LONQUIST & CO. LLC PETROLEUM ENGINEERS ENERGY ADVISORS AUSTIN HOUSTON  WICHITA CALGARY	OWL SWD Operating, Inc		Dinwiddie SWD No. 1	
	Country: USA	State/Province: New Mexico	County/Parish: Lea	
	Survey/STR: C-11-26S-33E	Site:	Status: To Be Drilled	
	API No.: 30-025-TBD	Field:	Ground Elevation:	
	Texas License F-8952	State ID No.:	Project No:	Date: 3/1/2016
3345 Bee Cave Road, Suite 201 Austin, Texas 78746 Tel: 512.732.9812 Fax: 512.732.9816	Drawn: MMC	Reviewed: SLP	Approved: SLP	
	Rev No: 1	Notes: Devonian completion with 4-1/2" Injection Tubing.

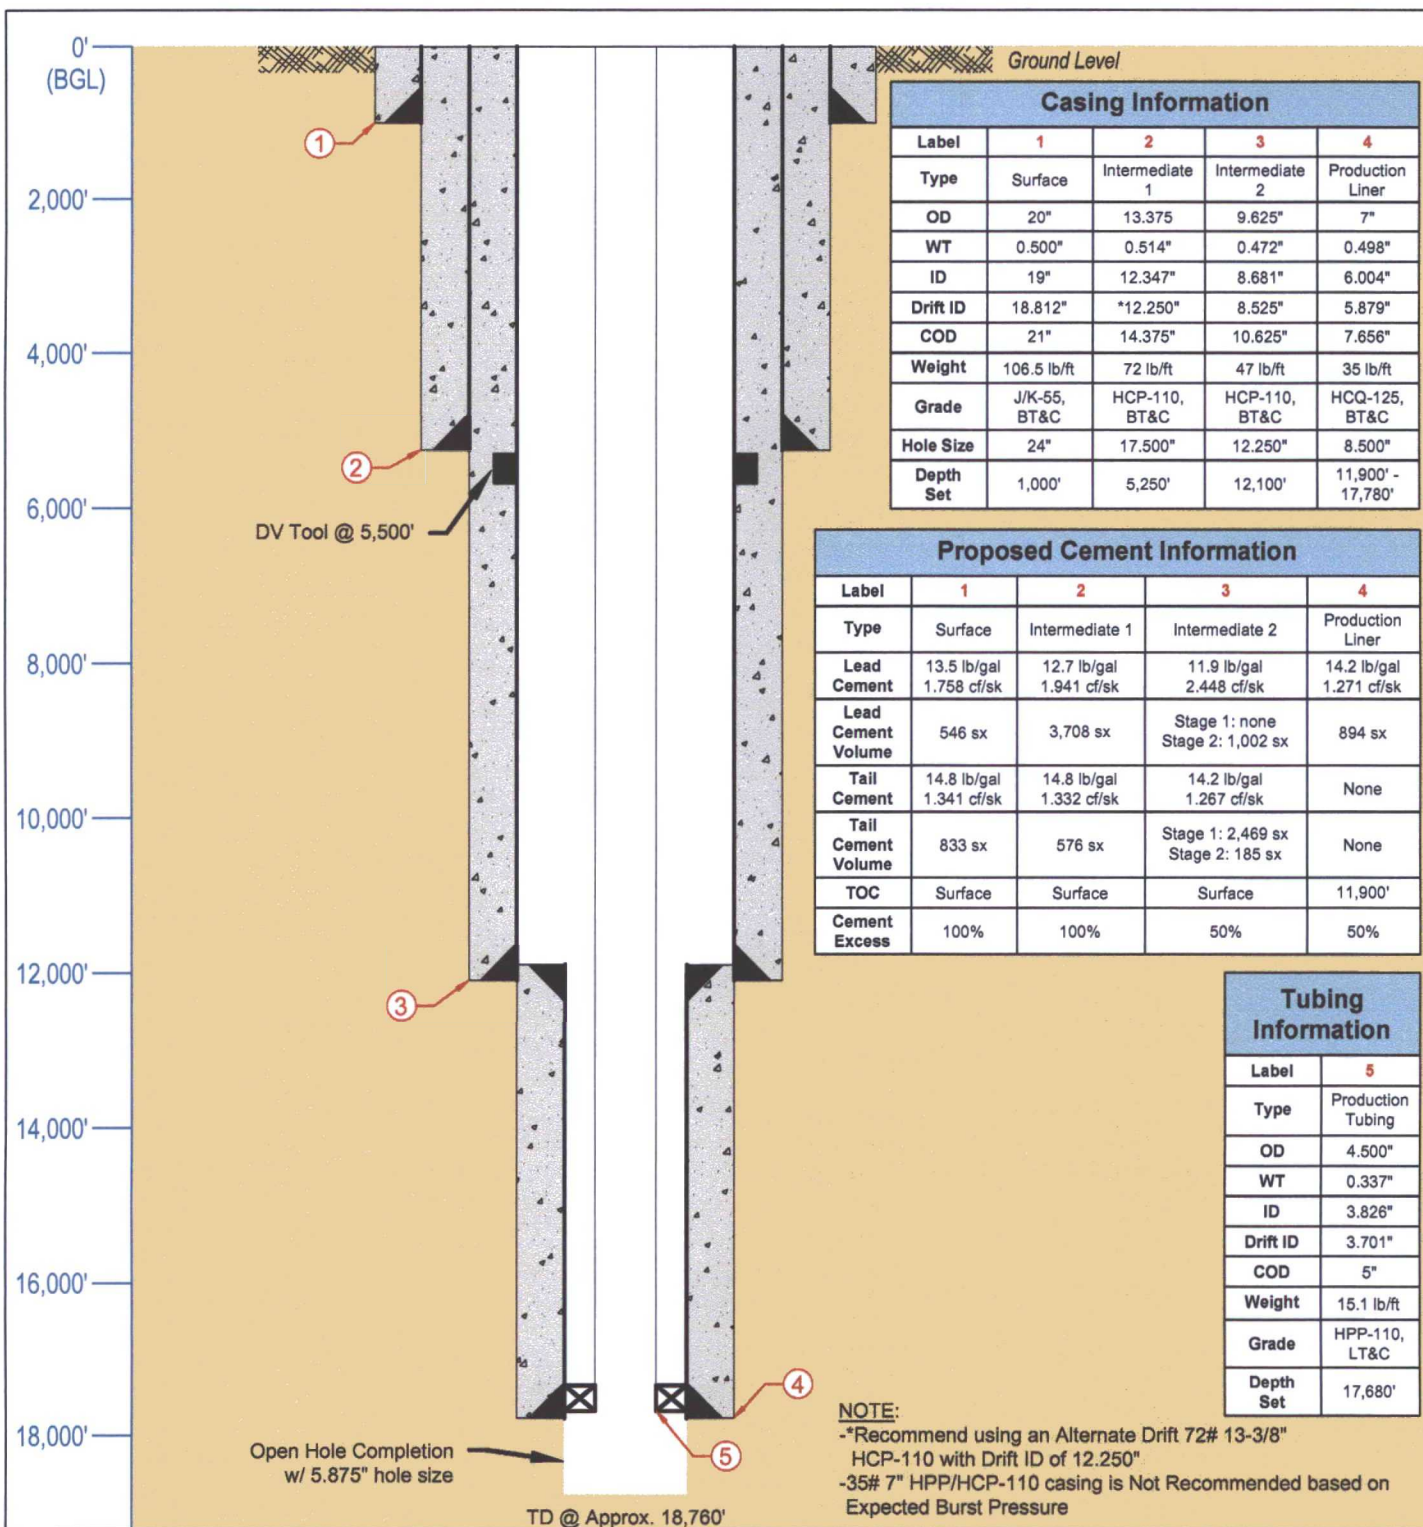
Burst Frac Gradient(s) for Segment(s) A, B = , b All > 0.70, OK.

Class 'H' tail cmt yld > 1.20

MASP is within 10% of 5000psig, need exrta equip?

Burst Frac Gradient(s) for Segment(s): A, B, C, D = 0.78,

Class 'H' tail cmt yld > 1.20

Capitan Reef est top XXXX.

MASP is within 10% of 5000psig, need exrta equip?
